Technical Bulletin

Doc No.:   **TN20-12**
Version: **1.0**
Date: **June 2, 1997**
Subject: **Unable to Download MC204 System Software via Serial Port**

Applicability: All boards prior to P130-00031

Fig.1 - Emulator Header

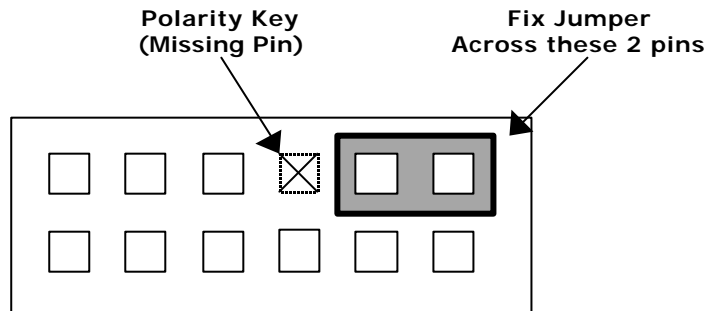
Details: In order to load a new version of the system via the serial port it will be necessary to connect a jumper across two of the pins on the emulator header on the PCB.

It is necessary to remove the side panel from the controller to access the header, which is located at the top right hand corner, near to the battery.

The jumper should be fitted across the two pins indicated in Fig. 1 below.

With this jumper fitted it will now be possible to download the new system software using Motion Perfect.

Please Note: You should remove the link before using the controller. If a further serial system download is required it will be necessary to repeat the procedure as above.
